SERVICE INSTRUCTION

REPLACEMENT OF THE CIRCLIP IN THE SPRAG CLUTCH HOUSING ON ROTAX® ENGINE TYPE 912 AND 914 (SERIES)

SI-912-006 R1

SI-914-008 R1

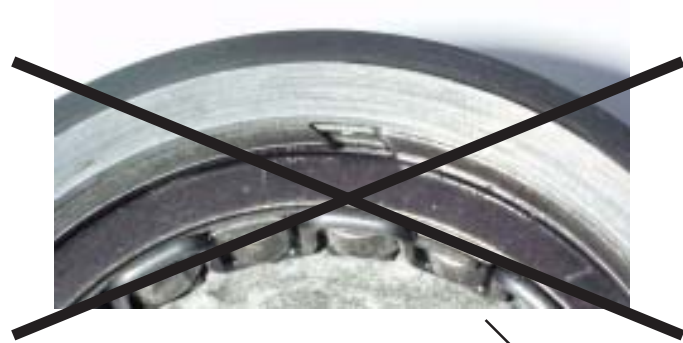
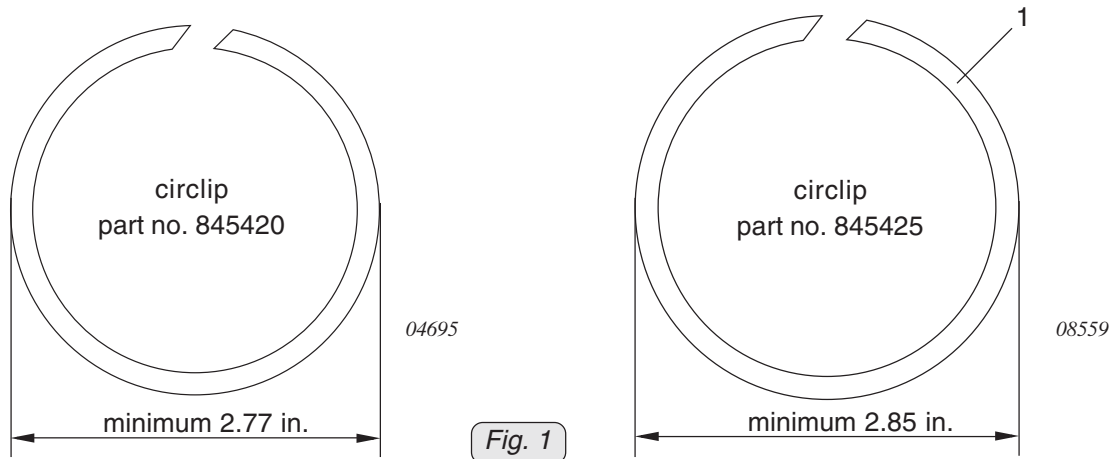
On repair work on sprag clutch (2) or at engine overhaul the circlip 68 part no. 845420 has to be replaced by the circlip 70 (1) part no. 845425. Verify by inspection if the new circlip 70 is already fitted. See fig. 1

Fig. 2

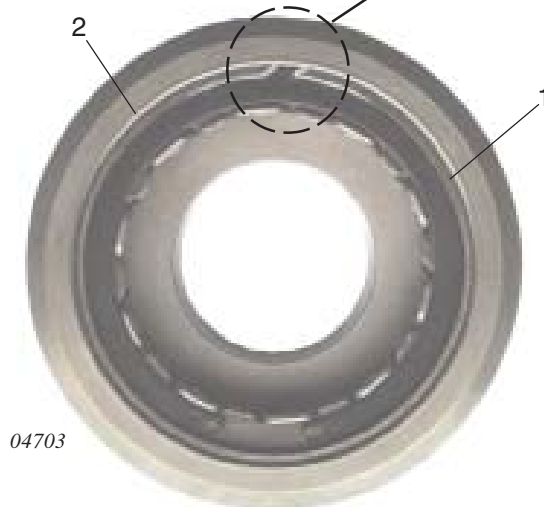
■ **CAUTION:** Make sure that the new circlip will be fitted as depicted in fig. 2 Detail A. To warrant a tight fit pay attention to correct position of the circlip ends (3).

The measurement of the circlip takes place in developed condition!

DETAIL A: shows the correct position of the circlip

DETAIL B: shows the incorrect position of the circlip
